Access Compliance Report

Public Rights-of-Way

(Curb Ramps)

Intersection ID: 10025412	Main Street: E_CARSON_BV	Cross Street: N/A	Location: S
ADA ID: 695C47D0DCCE	Ramp Type: Perp	Initial Pass/Fail: Pass	Overall Compliance: No
		Severity Score: 0

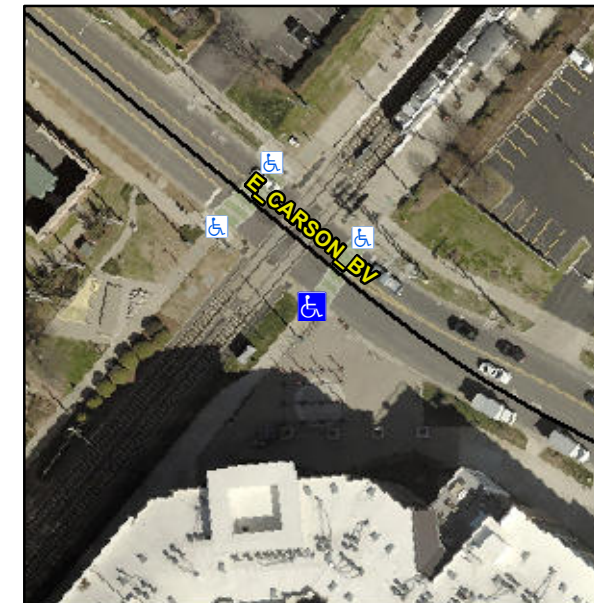
Not Found, R304.2.2-Perp, R304.3.2-Para

Remove & Replace Entire Ramp.
